WAIPA COUNCIL PLANNING REPORT

Technical Memos

Subject: Proposed Private Plan Change No. 11 Transportation Technical Report

Subject: 3 Waters Plan Change 11 - memo on applicants submissions 1 November 2018

Figure 1 showing new southern intersection, (BIL Ltd APL Master Plan Layout 10 Oct 2018.)

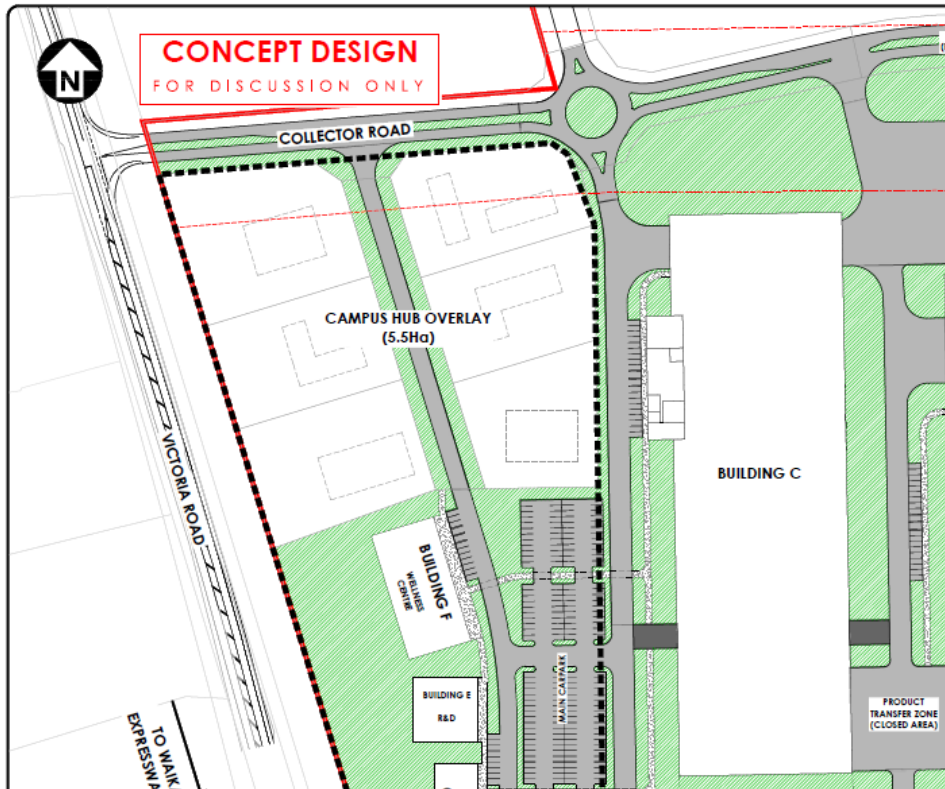
- Stage 1, enabling the APL development, could proceed with a right turn bay at a new southern intersection. The design would need to cater for expected stage 1 traffic volumes without impacting the Level of Service on Victoria Road and adjacent property entrances. (e.g. long queues on Victoria Road would be unacceptable).

- The southern intersection will be required to be upgraded to traffic signals, either within the timeframes of Stage 1 or Stage 2 with timing dependent on overall traffic growth, development traffic generation and safety performance. The design will need to ensure sufficient lane widths, shoulders etc., to ensure right turn queues do not hinder traffic flows on Victoria Road or regularly block adjacent vehicle entrances. It is expected that LOS will be C/D in peak hours but not LOS E/F. The intersection would encroach over and significantly along the current Kiwirail corridor to obtain the road width necessary.

- I note the Kiwirail submission states the southern intersection should be considered temporary. Reactivation of rail services would require closure of the southern intersection otherwise rail level crossings would be too closely spaced. Kiwirail's position is in keeping with Government policy and Regional spatial planning and prior agreements between Kiwirail, NZTA and Waipa District Council for intersections at the expressway, Norfolk Drive and Hamilton/Victoria.

- Laurent Road fronting the development and up to Victoria Road north must be physically closed to traffic to suit the new intersections. The Laurent Road reserve must be retained to accommodate utility services and future rail service resumption.

Figure 2 Two Roundabouts option (Graymatter concept 25 Sept 2018)

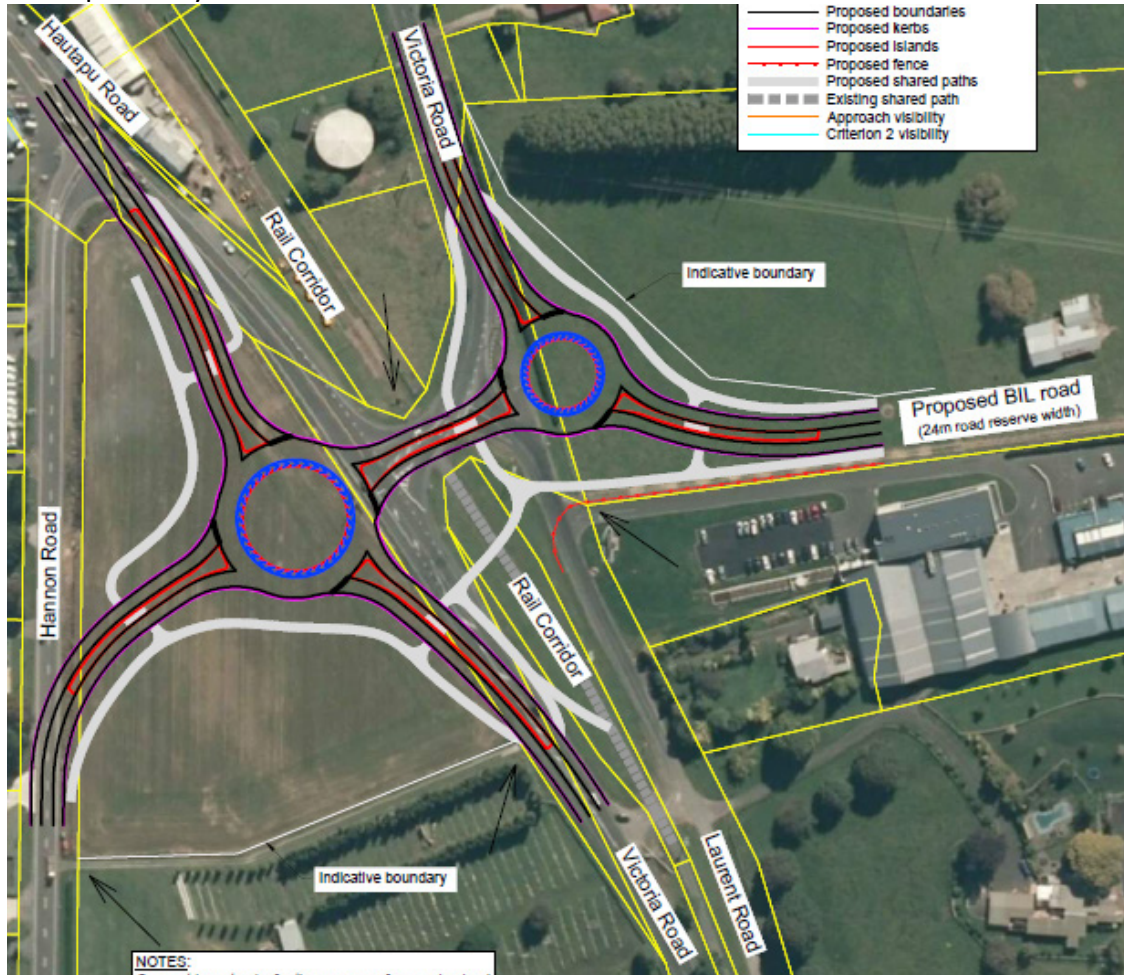
- BIL have offered two roundabout options for a northern connection. They are both shown in concept layout below.
- While both can accommodate the expected traffic volumes for 110ha of combined east and west industrial development the two roundabout option has benefits over a 5 leg roundabout. These include;

- greater separation of legs of the intersection allowing more time to see and give way or accept a gap to enter the roundabout
 - provides a much better future rail crossing option on a straight section of road between roundabouts

- can be staged to allow one roundabout to be built independently, and
 - new work is largely off line so there will be significantly less traffic disruption during the build.

- Access to the Shoof Industries site will need to be repositioned away from Laurent Road and on to the new access road into the BIL site. Laurent Road must be closed to vehicle traffic to ensure the new intersection operates safely.

- Shared walking and cycling paths will be required around the intersections to allow pedestrians to navigate to all quadrants and allow less confident cyclists to avoid the rotary areas.
